Technical Memo

To: Sven Exeter
From: Stefan Steyn (Senior Landscape Architect)
CC: Dean Foote
Project title Waipaoa Stopbank Improvements
Client: Gisborne District Council
Project number: 2-S5743.00
Subject: Landscape and Visual Effects Assessment
Date: 01-09-2026

Fig. 5: (Shelter hedge removed) Summer solstice sun study finding shadow from stopbank reaches edge of the building at approximately 7:00 p.m. on the summer solstice.

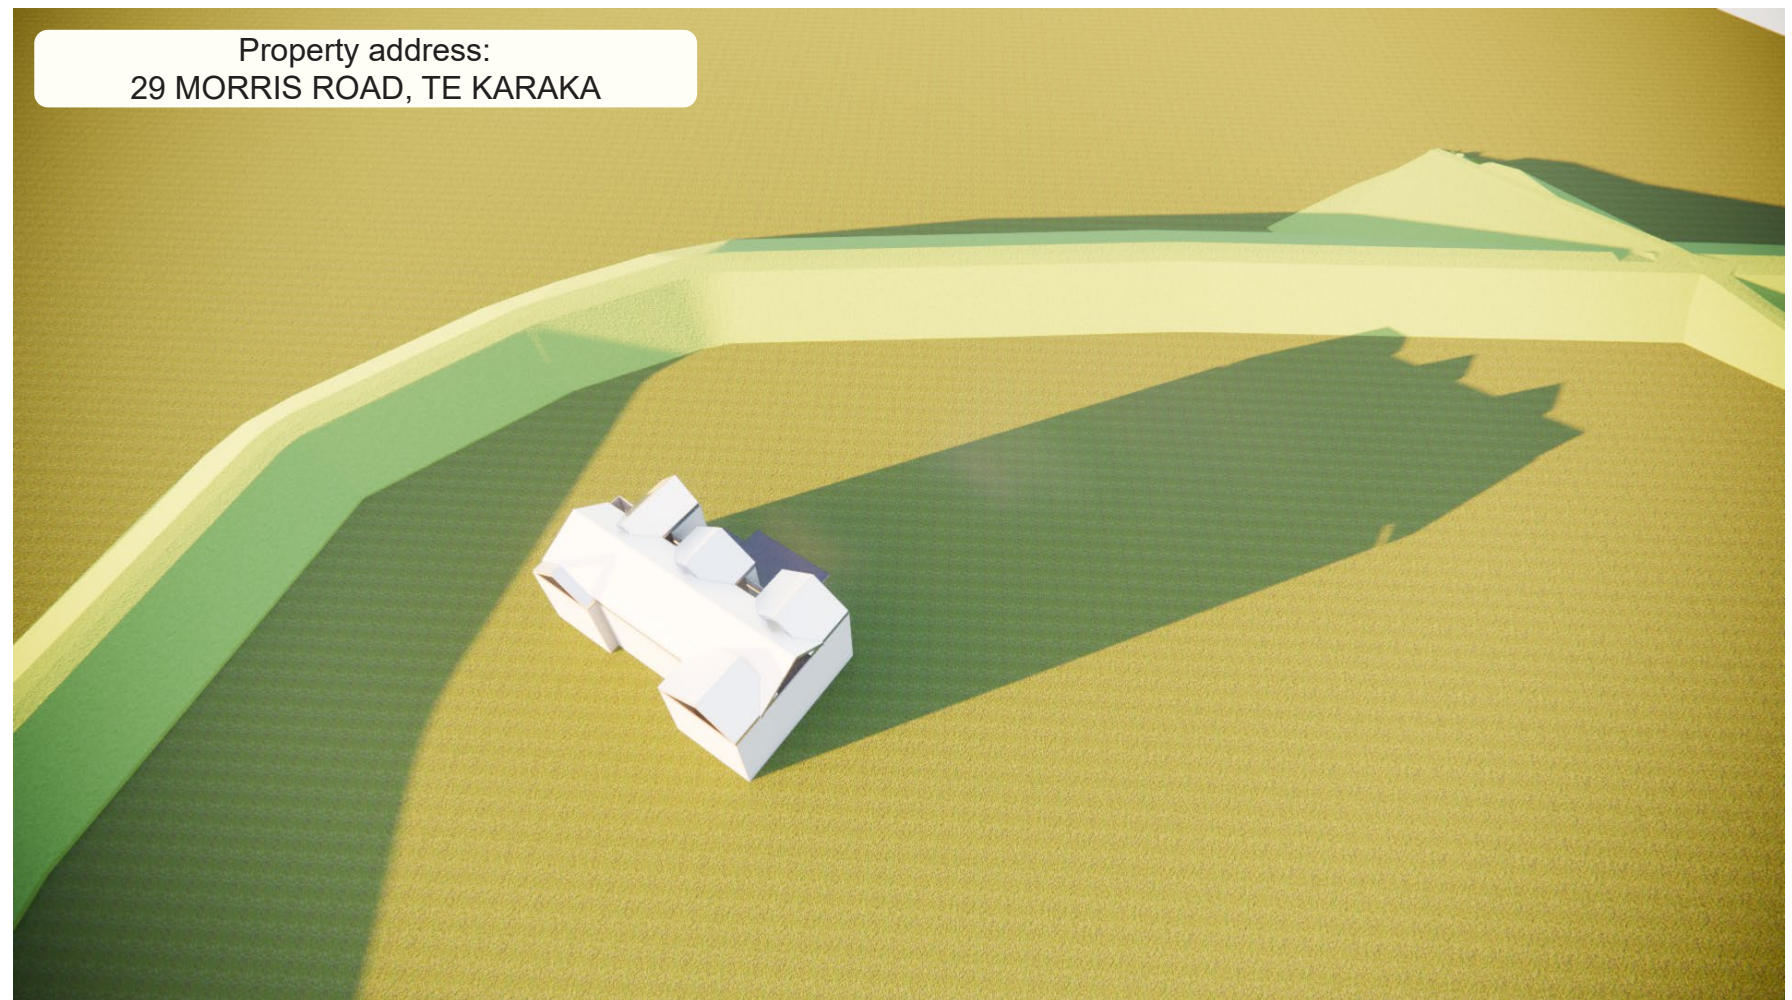
During the summer solstice, the stopbank would cast shadow onto the southern side of the dwelling from approximately 7:00 pm, with no shading effects on the outdoor living area (Refer Appendix A: Figure 5). The shelterbelt would similarly only affect the western side of the dwelling during the late afternoon. Given the timing, extent, and limited overlap with the principal outdoor living areas, the shading effects associated with both the stopbank and shelterbelt during summer are considered to be Very Low to Negligible.

Fig. 10: (Shelter hedge removed) Winter solstice sun study finding shadow from stopbank reaches edge of the building at approximately 4:00 p.m. on the winter solstice.

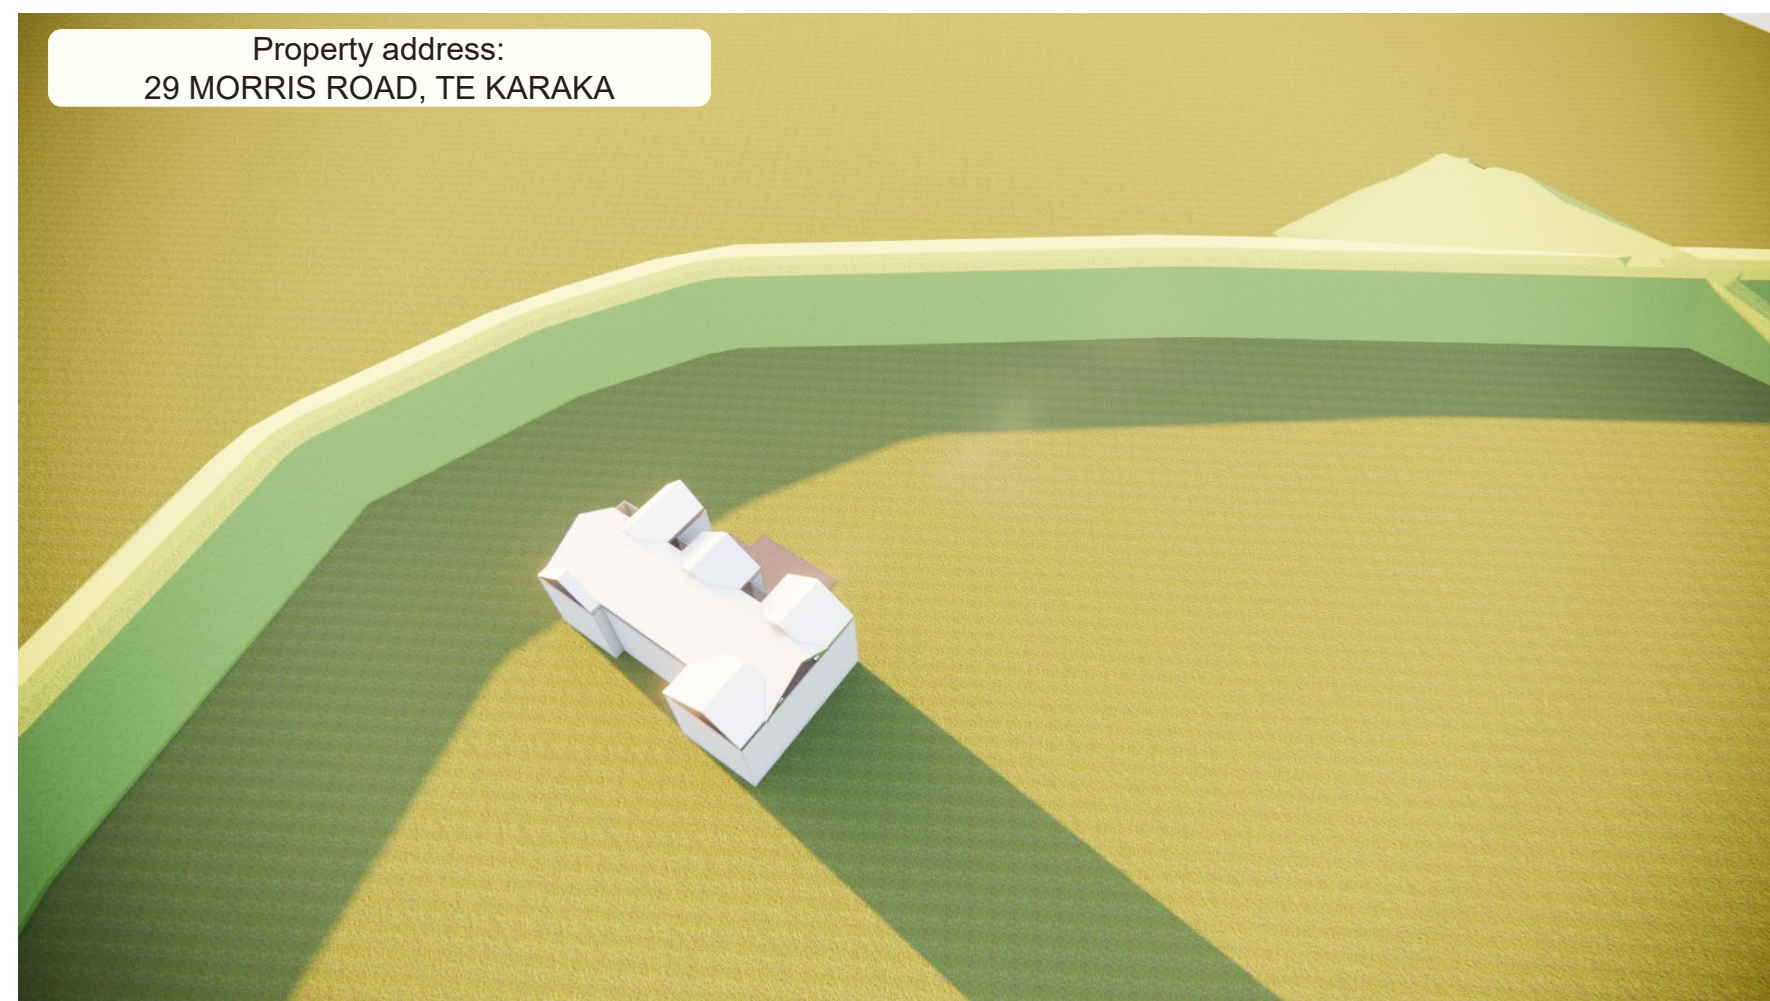
The results indicate that, by approximately 3:00 pm on the winter solstice, the existing shelterbelt shadow would cover the entire dwelling and outdoor living area. In comparison, the proposed stopbank

would begin casting shadow on the dwelling and outdoor living area at approximately 4:00 pm, when the sun is already at a very low angle above the horizon (Refer Appendix A: Figure 10). The outdoor living area would be entirely within the stopbank shadow at approximately 5:20 pm. This indicates that, by the time the stopbank shadow reaches the dwelling, the dwelling and outdoor living area would already be fully shaded by the existing shelterbelt. As a result, the additional shading attributable to the stopbank during the winter solstice is considered to be very small.

Fig. 19: Section B from building to the edge of the stopbank. Decking extent, house height and roof shape is indicative only to provide guidance on the scale of the stopbank.

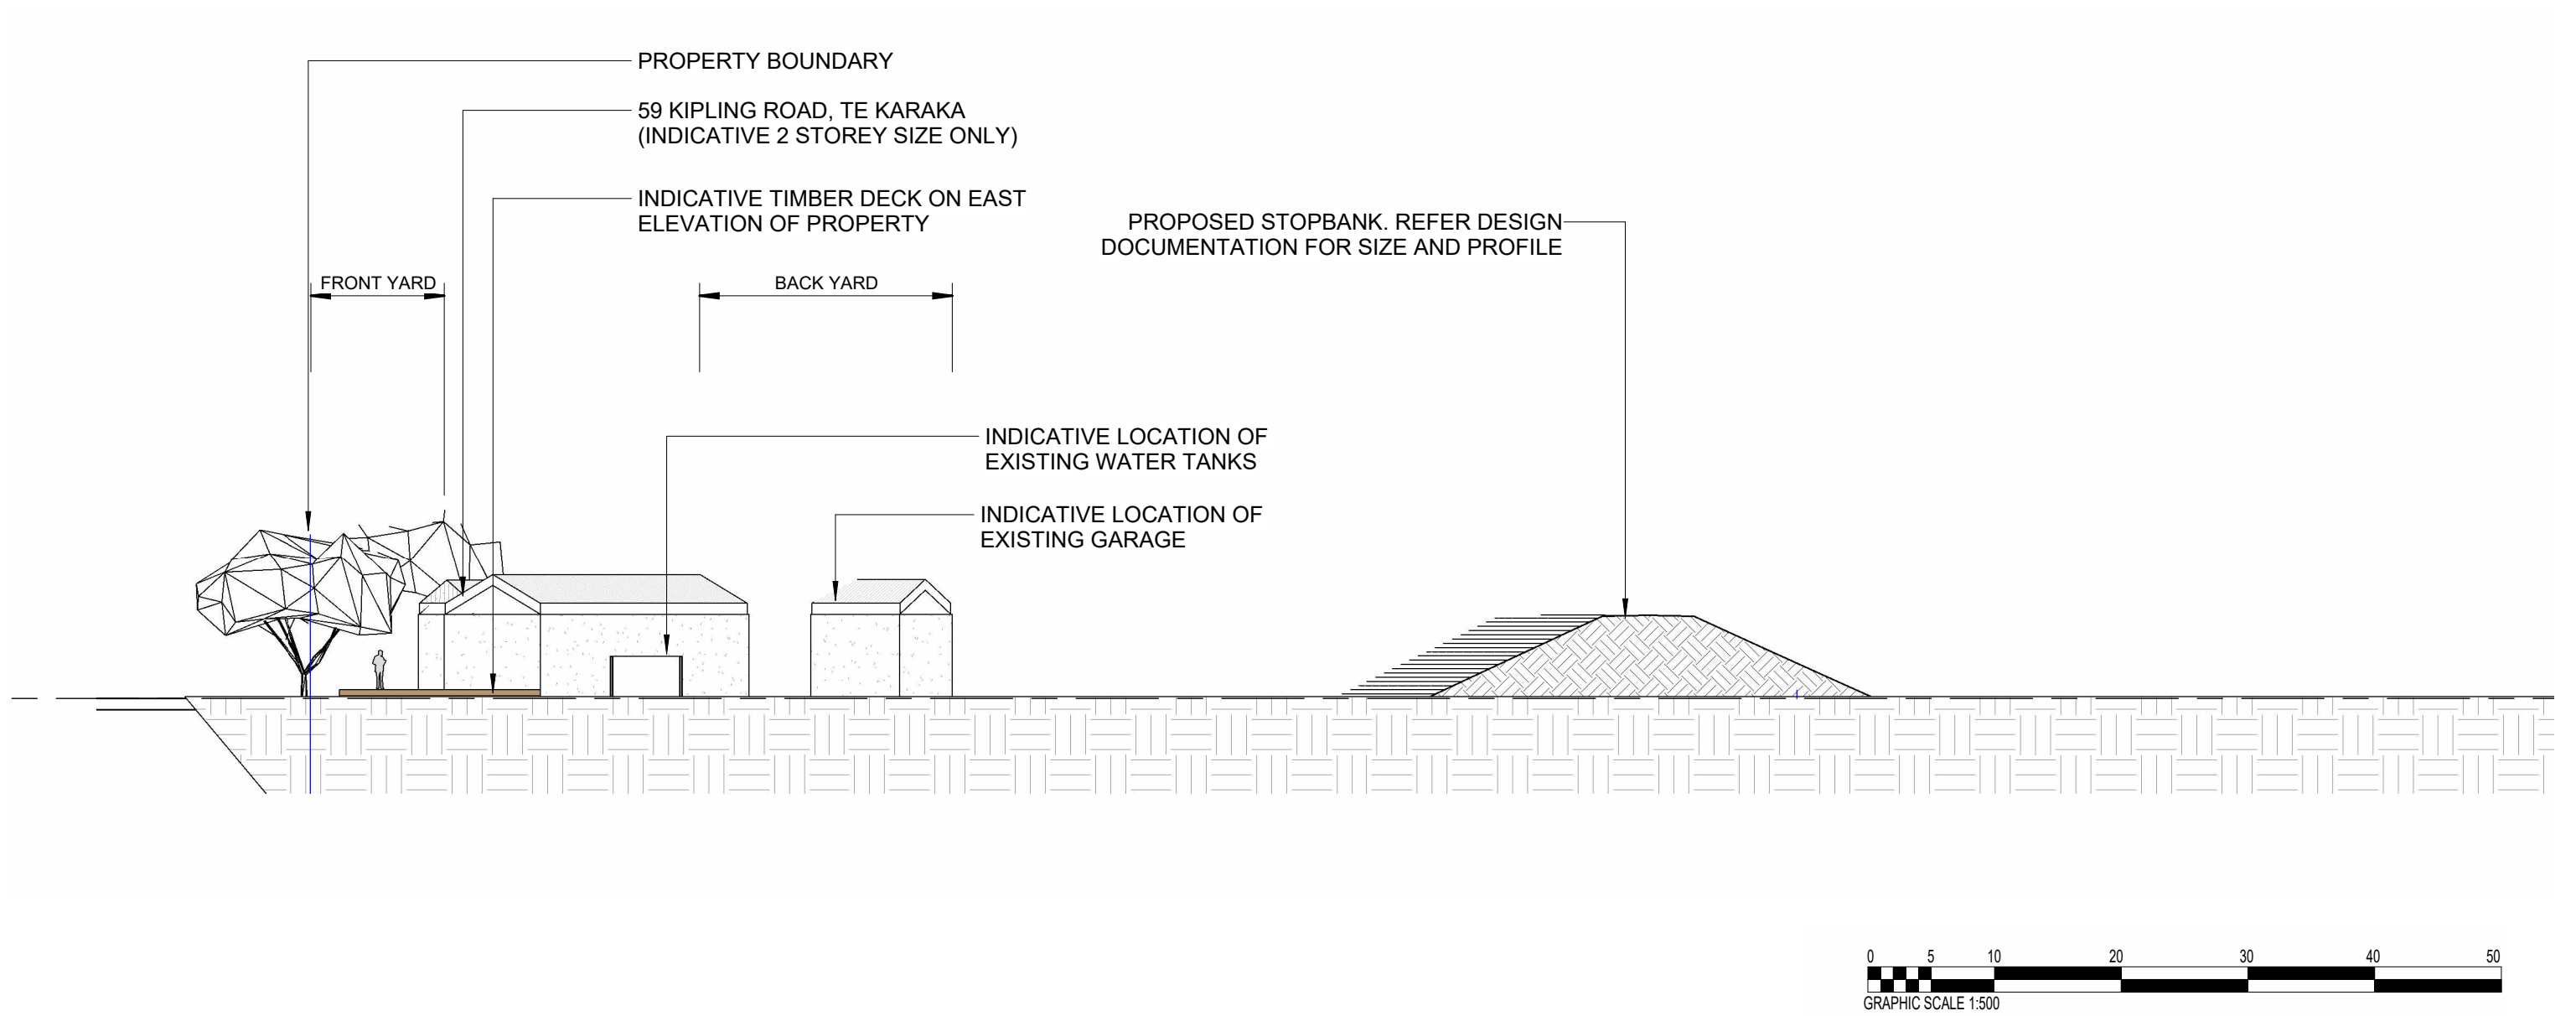
Given that the majority of the stopbank will be experienced from the rear of the property, and only a relatively small portion of the structure will be visible from the primary outdoor living area on the timber deck, viewer sensitivity is assessed as medium to low (Refer Appendix A: Figure 19).
